Bureau of Project Delivery Bridge Design and Technology Division

BRADD

No. 051
December 3, 2018

Release of Version 3.2.5.0

Example of a detail with MicroStation Note Elements created using MicroStation CONNECT Update 9

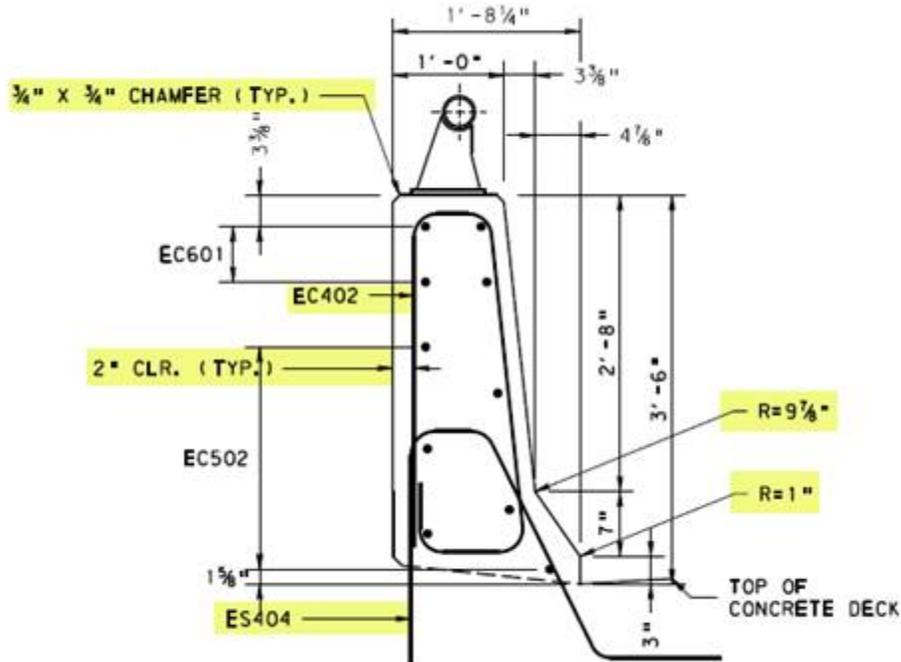
14. The MicroStation Place Note element has been implemented in BRADD when MicroStation CONNECT (version Update 9 or later) is used to generate the drawings. This means that a leader line with text will be treated as a single element that can easily be edited in MicroStation CONNECT. Previously, a leader line with text were placed as separate elements. (TFS 5121)
